**CULTURAL RESOURCES OFFICE
PRESERVATION BOARD
REGULAR MEETING
MONDAY APRIL 23, 2012
1015 LOCUST ST. #1200
4:00 P.M.**

DATE: April 23, 2012
FROM: Bob Bettis, Cultural Resources Office
SUBJECT: Preliminary Review to replace portion of rear brick wall with Exterior Insulation and Finishing System
ADDRESS: 2127 Utah St.
JURISDICTION: Benton Park Certified Local Historic District — Ward 9

DATE: April 23, 2012
FROM: Jan Cameron, Cultural Resources Office
SUBJECT: Preliminary Review: new single-family construction on two vacant lots
ADDRESS: 4274 Flad Avenue
JURISDICTION: Shaw Historic District — Ward 8

DATE: April 23, 2012
FROM: Jan Cameron, Cultural Resources Office
SUBJECT: Preliminary Review: rehabilitation of two attached one-story houses
ADDRESS: 1017-1019 Geyer
JURISDICTION: Soulard Local Historic District — Ward 7

NORTH ELEVATION FROM MISSOURI

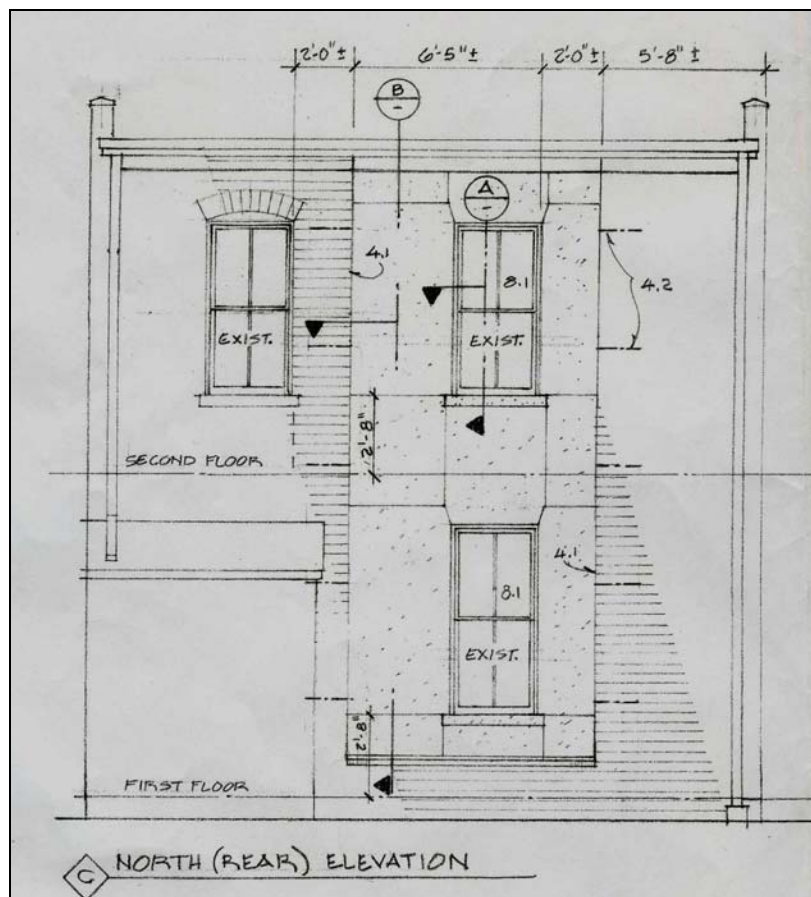
Does not comply. The owner is proposing to install E.I.F.S., a cementitious coating over insulating material, instead of a brick veneer. The entire new section is visible from the street and will alter the appearance of approximately a third of the rear wall of the building.

2127 Utah, constructed in 1890, sustained a collapse of the rear wall in 2011. Although the owner intends to re-establish the original fenestration pattern, the proposed reconstruction would not use one of the three options allowed in the standards. The proposed design uses E.I.F.S., which has a quite different texture, in a manner that its joints will create a non-historic pattern. As the property is a corner building, the section of the rear wall to be reconstructed is quite visible from the street and is only a few feet from the sidewalk, a distance at which materials are readily identifiable.

The Cultural Resources Office recommends that the Preservation Board deny the preliminary application as the proposed work is not in compliance with the Benton Park Historic District standards and would present a non-compliant condition easily perceived from the street.

STREET ELEVATION SHOWING PROPOSED HOUSE IN CONTEXT WITH EXISTING FABRIC

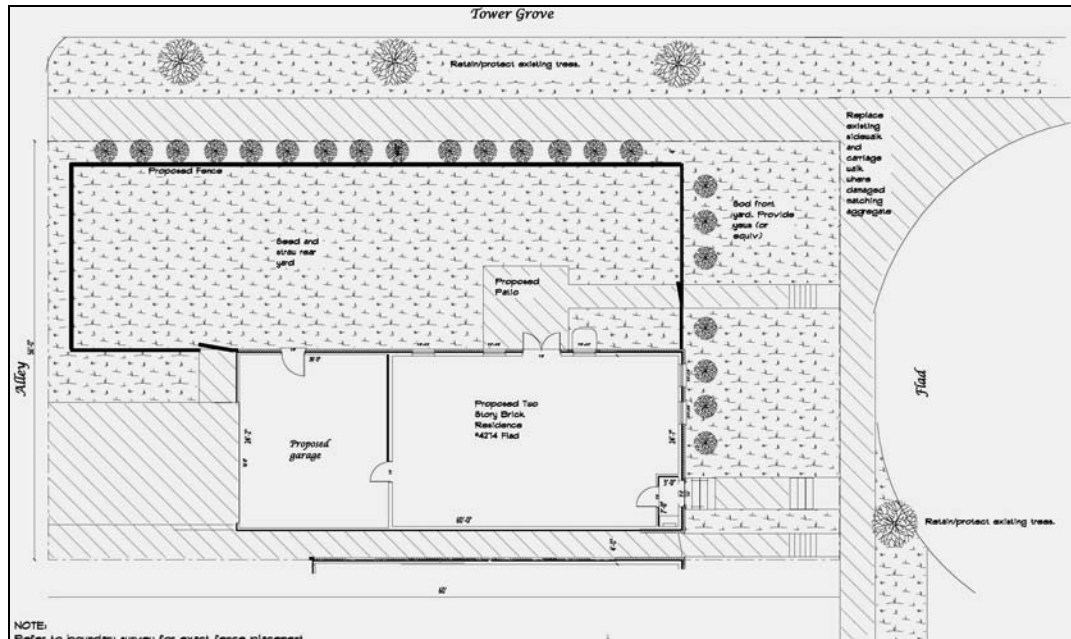
Complies. Based upon the street elevation submitted, it appears that the building will be within 15% of the average height of buildings on the block and floor-to-ceiling heights are similar.

WEST ELEVATION — NOTE TWO ENTRANCES AND BASEMENT EGRESS WINDOW

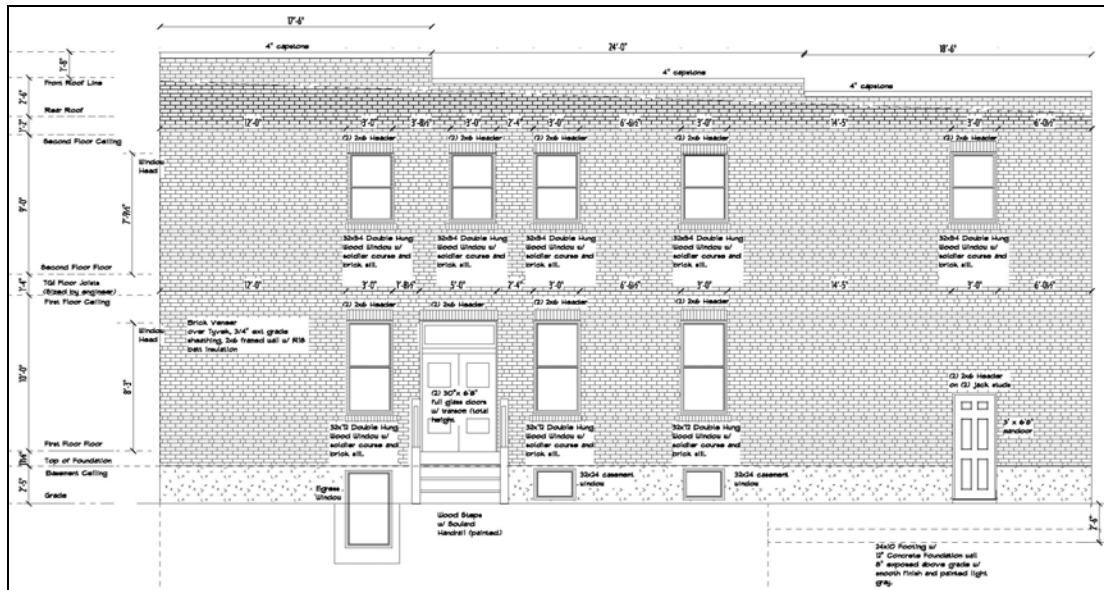
In addition, the inclusion of a double-leaf entry on a secondary street-facing elevation is not characteristic of other properties in the vicinity; nor is the basement egress window also shown on the elevation above.

The Cultural Resources Office recommends that the general design be approved as proposed; but that the design include a projecting entrance porch, one-story or one-story with balcony, on the front façade, and larger windows be used on the façade to provide a more balanced elevation and also to augment the house's compatibility with surrounding properties. While the openings proposed for the western elevation are not characteristic of historic properties in the neighborhood, the Shaw district standards do not require conformance with a model example, and due to the lack of a sizable rear yard, it is not unreasonable to provide access to what will be the homeowner's main outdoor space. The proposed entries are understated and will not visually detract from the main design. However, the Office strongly recommends that the proposed egress window on this elevation be removed to the rear of the building; if this is not possible, extensive screening must be installed.

PROPOSED RAMP AND NEW ACCESSIBLE ENTRY

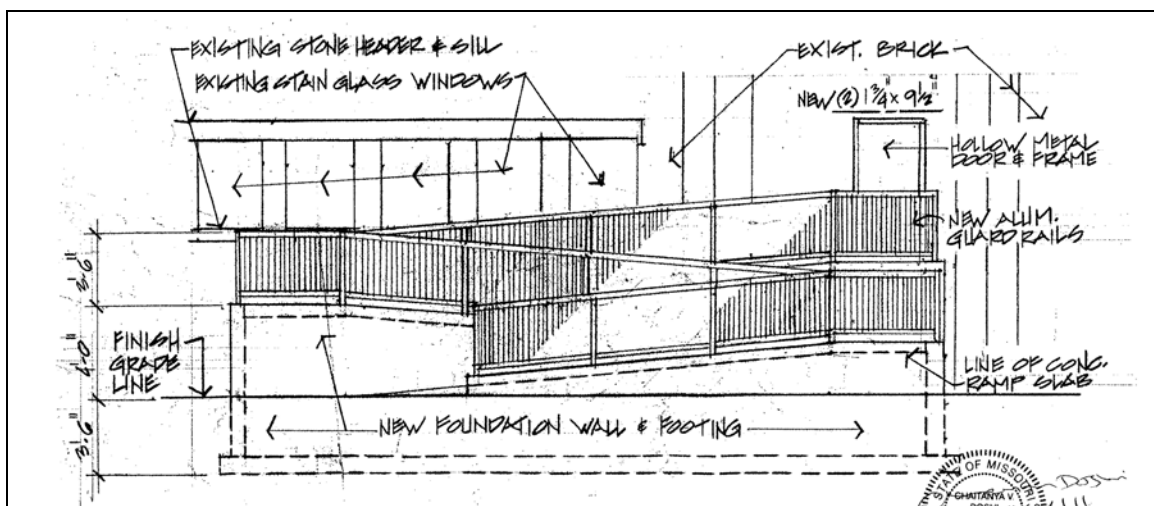
Does not comply. Existing architectural details at the front façade are proposed to be altered and the ramp would obscure part of that façade. Above-grade basement windows on the front façade would be infilled and the paired lancet windows on the main level would be removed to install a new door. This opening would be reshaped to accommodate the new accessible entry door.

In the balanced, yet asymmetrical design of the façade of this church, the paired lancet windows with prominent terra-cotta arches have a strong presence in the shorter south tower form. The proposal does not comply with the Hyde Park Historic District standards in that these windows and other architectural elements would be altered by the ramp and door installation. Other options, such as a ramp on the Angelica St. side of the building, should be considered. Placing the ramp on the Angelica Street façade would lessen the impact of the ramp on the architectural details of the building.

The Cultural Resources Office recommends denial of the accessible ramp and façade alterations as they does not meet the Hyde Park Historic District standards.

PROPOSED ELEVATION FACING LEMP

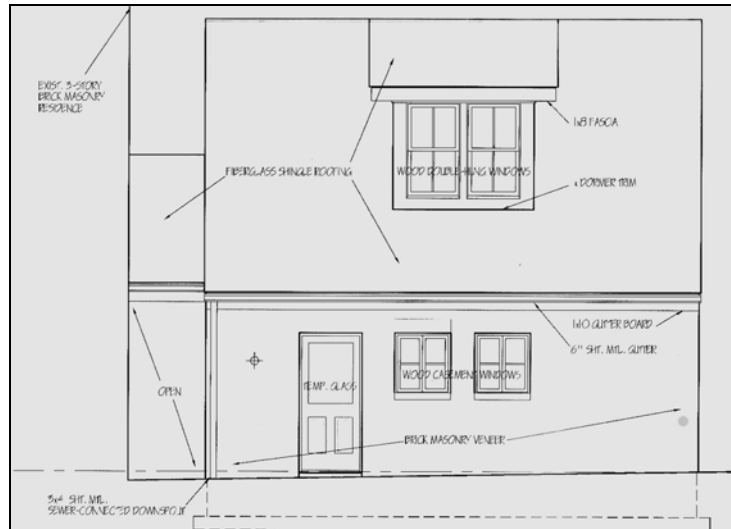
Does not comply. The scale of the proposed building is much larger than is typical of garages and even carriage houses in the neighborhood. The height of the roof ridge extends to 22 feet. The garage's placement on the site well in front of the rear property line increases sense of being over-scaled. The steep roof pitch and three sets of dormers dominate the building.

As proposed, the new building does not have the preferred location of a garage and is not perceived as a garage due to its tall upper story. The west façade facing Lemp Avenue will be very street-visible behind a proposed wrought-iron fence at the street. It fits into neither the category of a garage nor new construction based on a Model Example. The Cultural Resources Office contends that placing a large 1½-story garage in the side yard quite a distance from the

Staff recommends that the Preservation Board withhold preliminary approval at this time until either the proposed garage is repositioned as a garage, behind the main building or at the rear lot line, and its design altered or until a Model Example for it is submitted to comply with the district standards for new construction.
